## **ADOPTION STATEMENT**

### **PARKING STANDARDS SUPPLEMENTARY PLANNING DOCUMENT**

**TABLE 1 Changes following consultation on the draft SPD**

Figure 1 Parking space dimensions next to wall

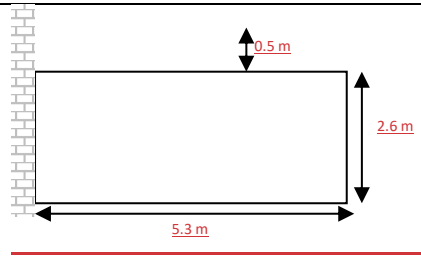
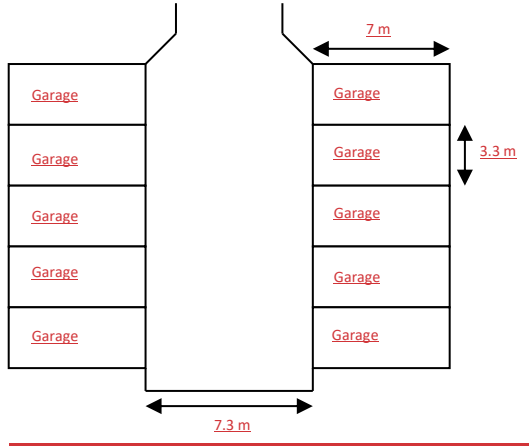
3.1.2	The materials used to provide parking should enhance the street scene rather than detract from it. Appropriate planting and landscaping can also be incorporated to encourage opportunities for <del>increasing</del> biodiversity and enhance the quality of the built and natural environment.	Minor clarity change
Figure 2		Clarity of space requirements adjacent solid objects

*Figure 4. Types of cycles<sup>9</sup>*

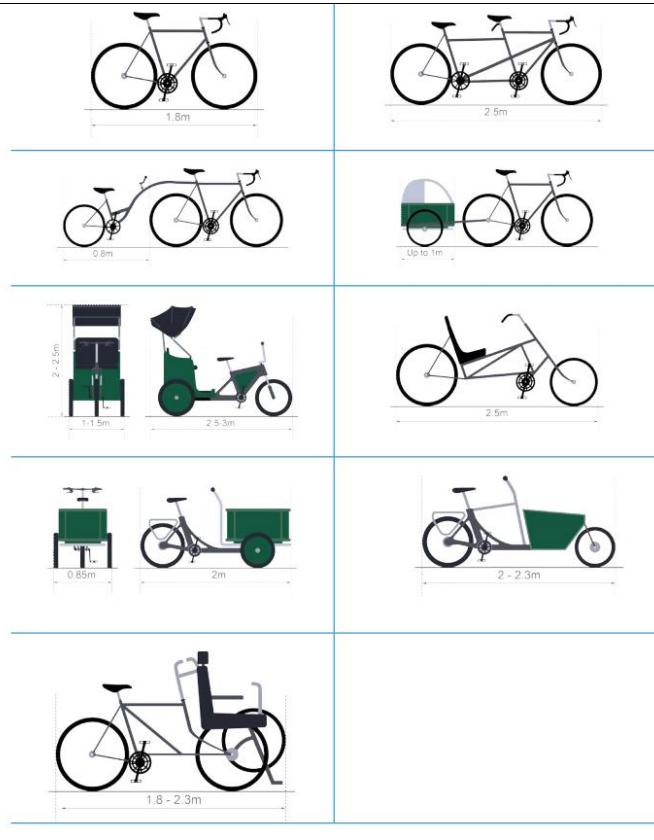
3.3.10	<p><del>It is very important to recognise that there are various types of cycle (as shown in Figure 11) and many types of people using them. <u>Cycle parking needs to take into account all user needs, so as not to exclude or disadvantage riders of certain types of cycle.</u></del></p>	Improved clarity and consistency with national policy

**Replacement higher quality diagram**

Figure 6 Option A Secure covered (inc. residential)

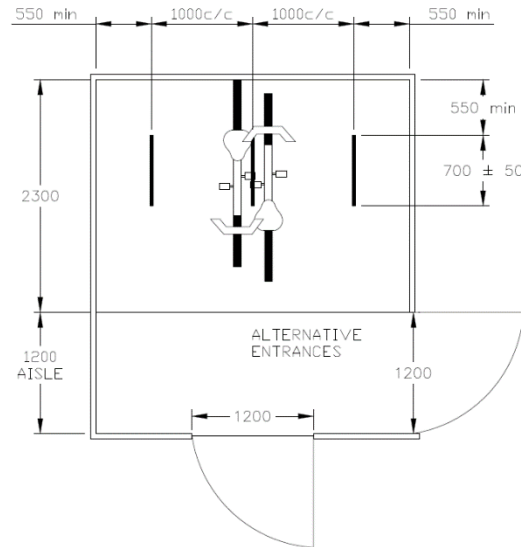
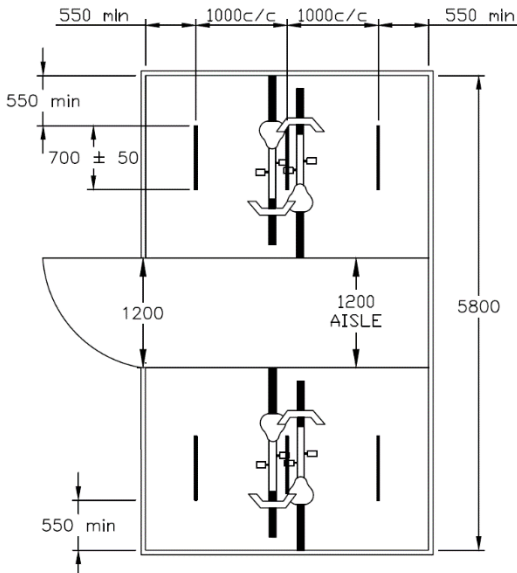
3.3.31	<del>Sheffield type stands within the cycle stores should be</del> Sheffield type stands within the cycle stores should be placed in accordance with Figure 19 and Figure 20. Access aisles should have a minimum width of 1.2m between parked bicycles. If double stacked cycle parking is proposed, <del>an increase to at least 2.5m (ideally 3m) depending on</del> <u>an increase to at least 2.5m (ideally 3m) depending on</u> <del>the manufacturer's specification, lowered frame</del> <u>is required, increased to a minimum of 3.5m where double-deck stands line both sides of the aisle.</u> A minimum of <del>2.6m</del> <u>2.7m</u> head height is required to ensure the system is usable. Access doors should have a minimum width of 1.2m. <del>Each</del> <u>Every</u> cycle space should be accessible and not obstructed by other cycles in the store.	Improved clarity, grammatical changes in line with consistency changes within section 3.3

**Higher quality diagram**
